**Water Budget Evaluation for
a Proposed Reservation for
Lake Hancock and Lower Saddle Creek
in Polk County, Florida**

December 2019
Peer-Review Draft

Figure 1. P-11 raw data, rating curve, and Adj P11 Q under operating rules

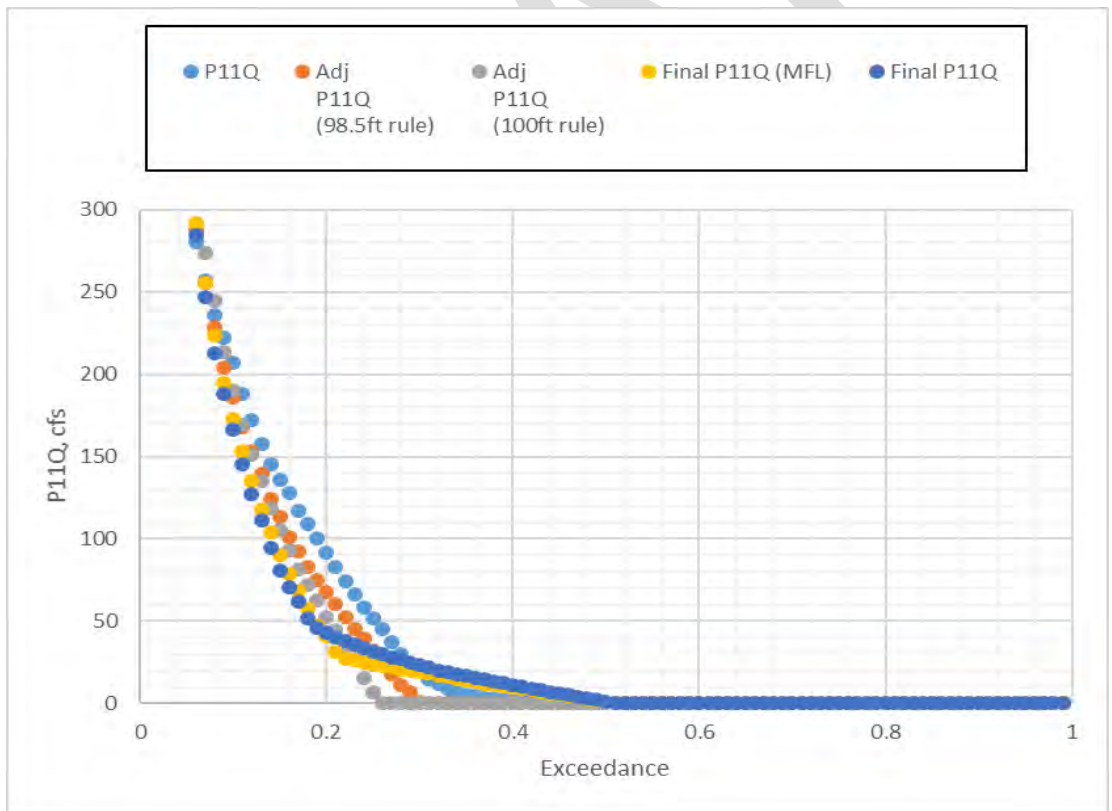
Comment No.	Figure, Table, or Page and Paragraph Number	Does Comment Directly and Materially Affect	A. Reviewer's Specific Comments	B. District Response
			discussion include a) stage-duration curves (for example, Figure 3 of Attachment A), b) contour map of lake bathymetry, c) LH stage-surface area relationship, d) map(s) of P50 inundation area, and e) limited discussion (from prior LH studies of ecological effects of new P-11 and operational schedule).	
7	Pg 20,21	No	Consider a table up front that describes the water budget model setup up and model scenarios. I.e., explain historic, baseline and other operating scenarios. Refer to something like attached Figure 1 (Attachment A) to compare the raw data, rating curves and how scenario flows fall (as they must) on the rating curve. The objective of the table is to have important information for the different scenarios in one location for reference.

Figures 2 A,B,C. Flow duration curves for P-11 operating scenarios at different scales

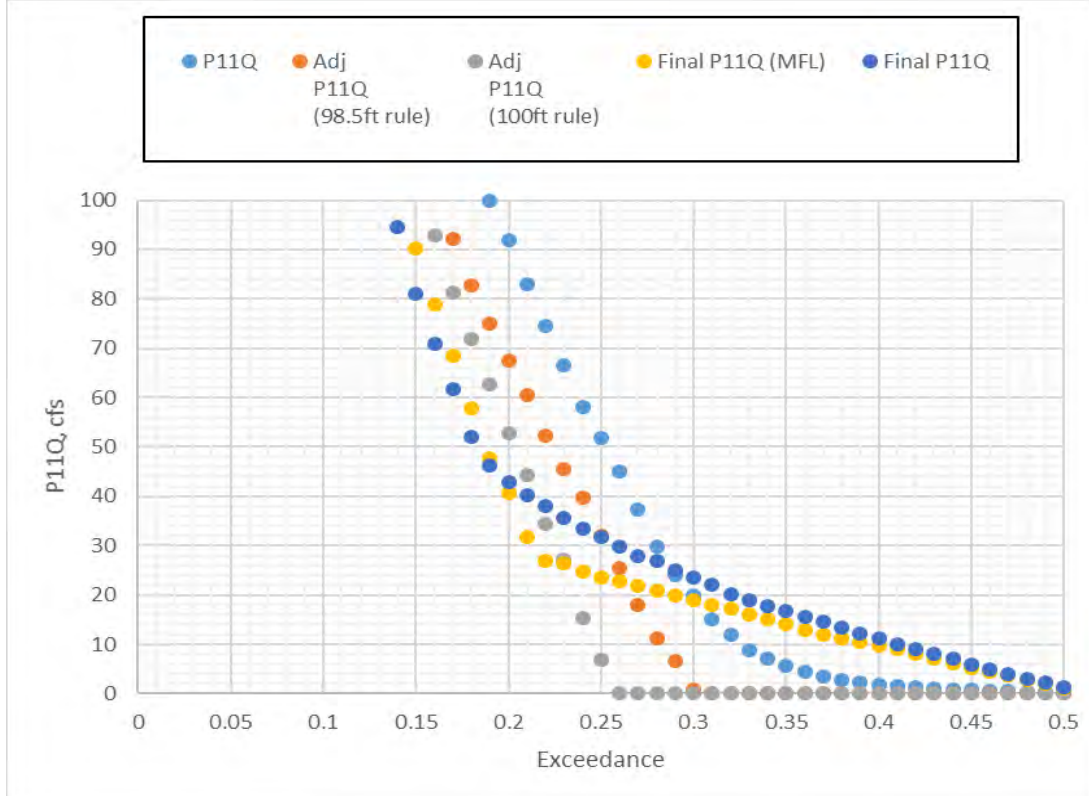
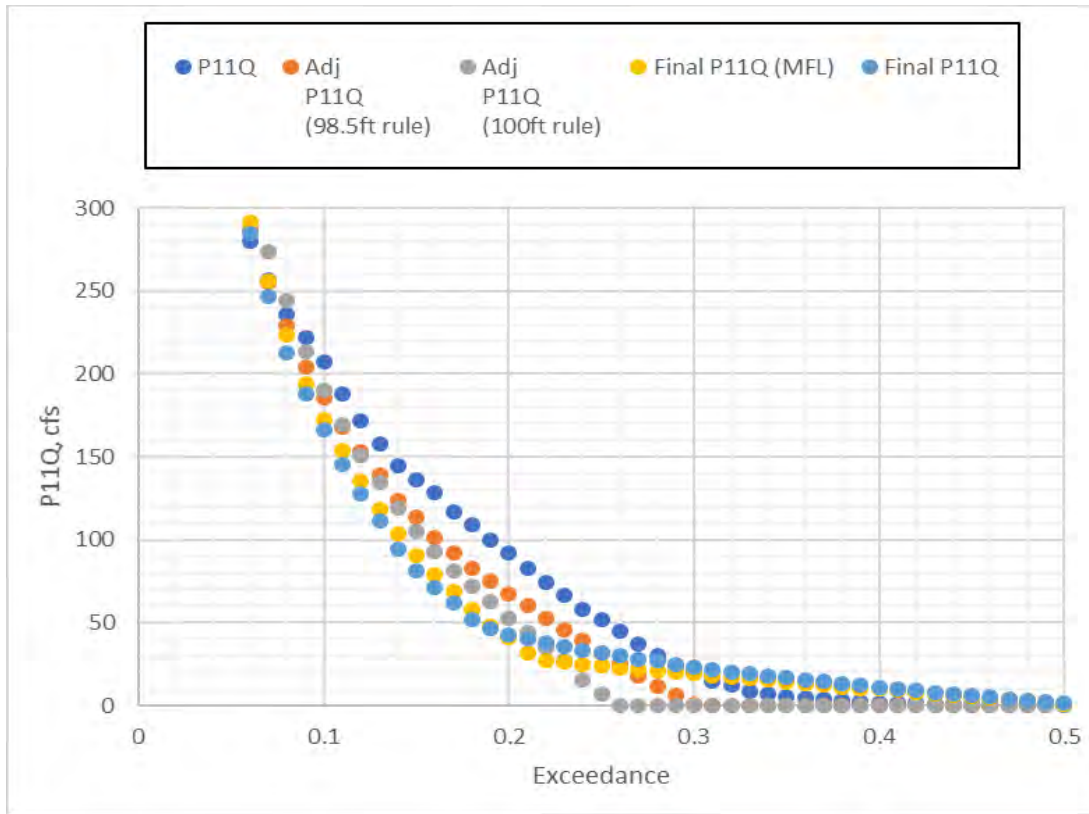
Several duration curves were provided in the comments (Table 1) which may help with displaying the impacts differently than the bar charts presented in the report. For example, Figure 3 (in Attachment A of Table 1) is a lake stage duration curve (SDC) under the various model scenarios along with regulatory levels. Figure 2 (Attachment A of Table 1) depicts flow duration curves (FDC) for the various scenarios and identifies clearly where the MFL augmentation flows are coming from on the FDC, for example.

Figure 10. Contour map of lake bathymetry for Lake Hancock

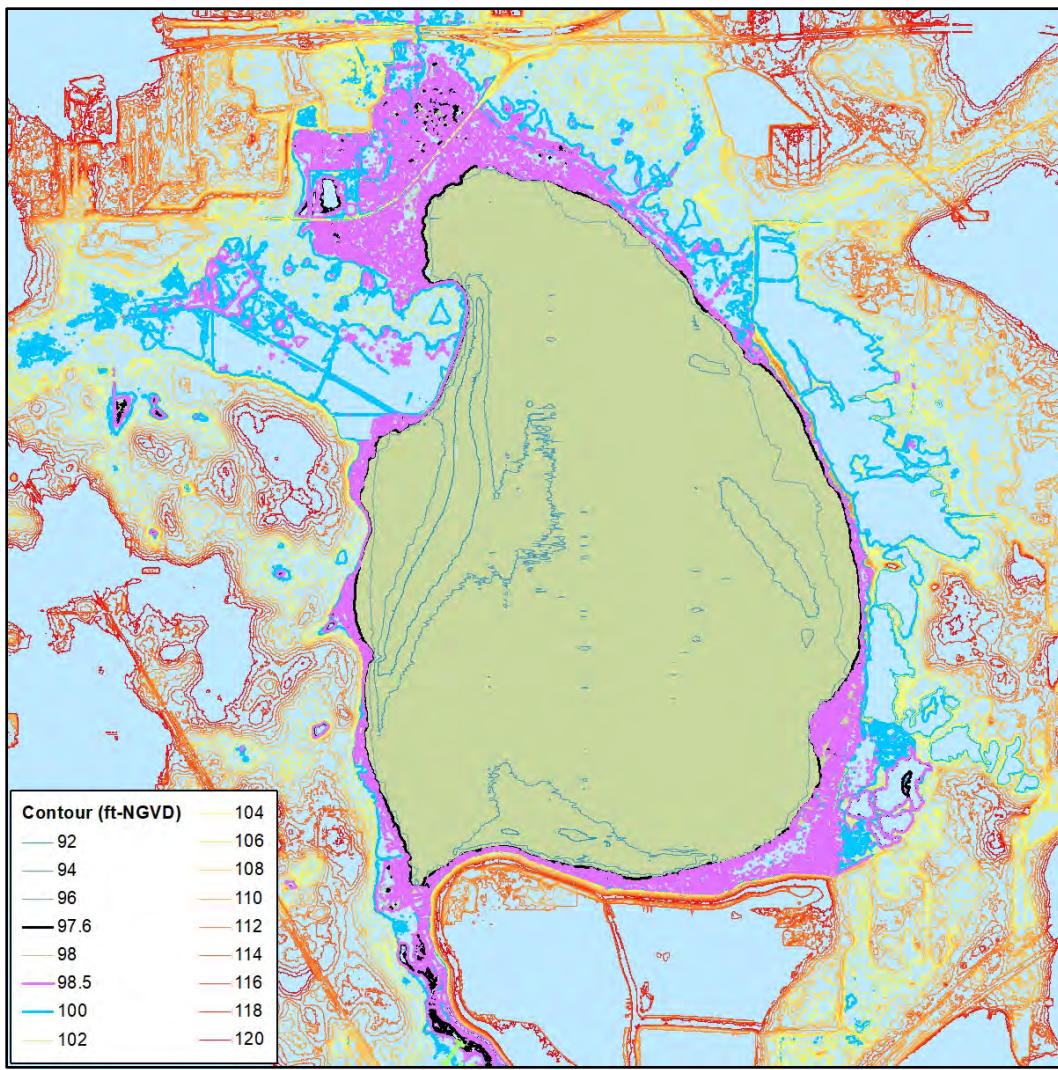
7	Fig. 10	No	It appears that flows above 10 cfs at Fort Meade were reported to the nearest cfs. Also Figure title is on the next page	Just an observation, but Figure title should stay with the Figure
8	Page 21	Potentially	The mathematical discussion of how adjustments were made to downstream flows should be elaborated on for understanding or clarity. May have to adjust outfall discharge estimates based on what happened historically at USGS gauge at Bartow.	Basically whatever adjustments were made at Bartow because of changes in P-11 discharges should be reflected similarly at the other downstream gauges
9	Pg. 23, 1 st bullet	No	Recommend getting rid of in which to be consistent with wording for remaining bullets	Remove "in which"

A. Reviewer's Specific Comments	B. District Response
11	Fig. 10	No	It appears that flows above 10 cfs at Fort Meade were reported to the nearest cfs. Also Figure title is on the next page	The data used for the plot were downloaded from USGS. District staff noticed the format of the data is not consistent over the period of analysis (e.g., one decimal place is shown for data values less than 100 cfs but greater than 1 cfs for the period since water year 2002). The District used the original downloaded data and no alterations were made. The x and y axes labels used for the report figure were formatted to include no decimal places.
12	Pg. 21	Potentially	The mathematical discussion of how adjustments were made to downstream flows should be elaborated on for understanding or clarity. May have to adjust outfall discharge estimates based on what happened historically at USGS gauge at Bartow. Basically, whatever adjustments were made at Bartow because of changes in P-11 discharges should be reflected similarly at the other downstream gauges.	To better present model development, model setup and adjustments, Section 2.3 was restructured, and additional text was added per both reviewers' comments. We note that the adjustment in P-11 flow is reflected in flows for all downstream gages. However, sites downstream of Bartow have additional impacts due to sink loss.

Figure 152. Lake Hancock stage duration curves associated with for structure P-11 operating scenarios and adopted lake minimum levels for the lake including regulatory levels

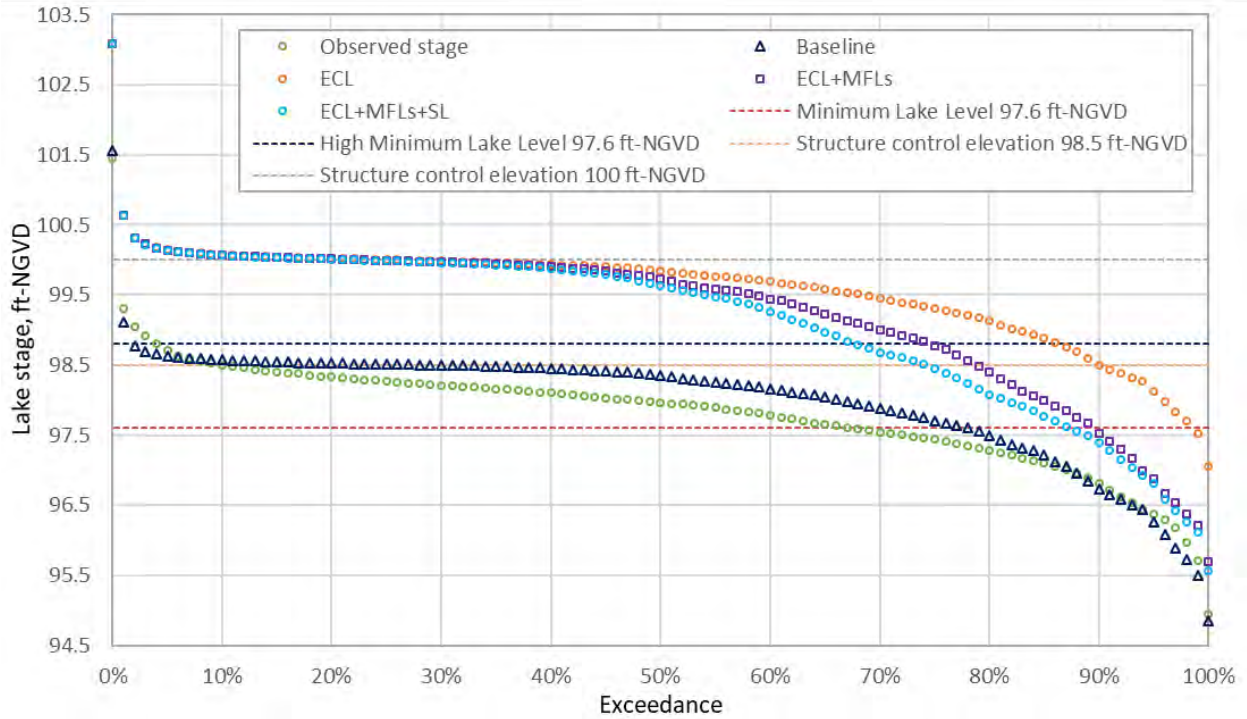
15	Figure 12	No	Consider explaining why the P50 lake level for baseline scenario is 0.7 feet higher than the P50 (Minimum Lake Level) adopted by rule. Consider adding results for the time series of observed lake stage to Figure 12.	
Tables				
16	Table 5,	No	Same as above. Consider explaining why the P50 lake level for baseline scenario is 0.7 feet higher than the P50 (Minimum Lake Level) adopted by rule. Consider adding results for the time series of observed lake stage to Table 5.

15	Fig. 12	No	<p>Consider explaining why the P50 lake level for baseline scenario is 0.7 feet higher than the P50 (Minimum Lake Level) adopted by rule. Consider adding results for the time series of observed lake stage to Figure 12.</p>	<p>Additional text explaining why the baseline scenario is 0.7 ft higher than the Minimum Lake Level (which is the water level that must be equaled or exceeded 50% of the time on a long-term basis) was added in the second paragraph in Section 3.3 (originally Section 3.4). Staff notes that information describing required exceedances for the adopted Minimum Lake Level and High Minimum Lake Level (which is the water level that must be equaled or exceeded 10% of the time on a long-term basis) is included in the section. This information, along with tenth and fiftieth exceedance percentiles for the scenarios assessed with the water budget model was presented to explore compliance with the adopted lake levels for the modeled scenarios.</p>
